The City of Peachtree Corners

Addendum #2

RFP #18-005

TOWN GREEN CONSTRUCTION PROJECT (REVISED)

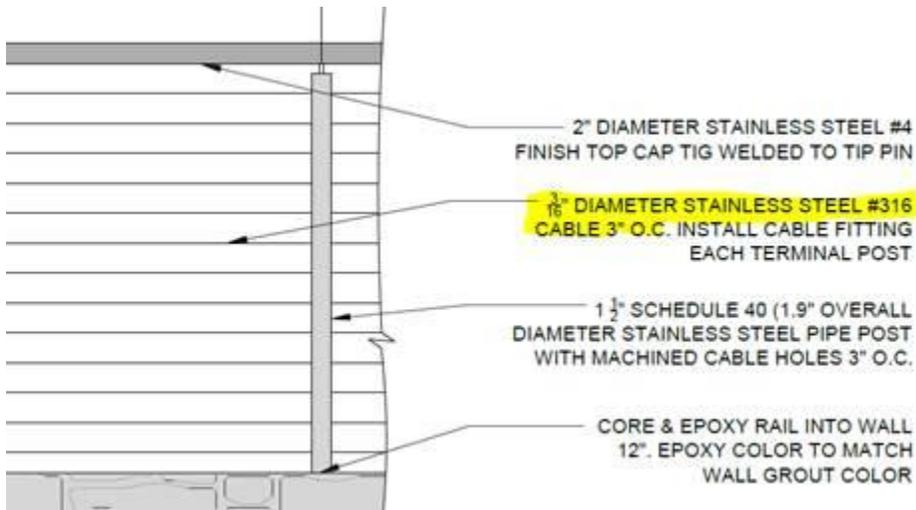
9. On sheet L4.01, there is an icon shown (attached as "unknown icon style" shown but with no description. What is this icon supposed to represent?

This is the symbol for the pedestrian light poles. They are not in the contractors scope of work. GA Power will cover pedestrian light poles.
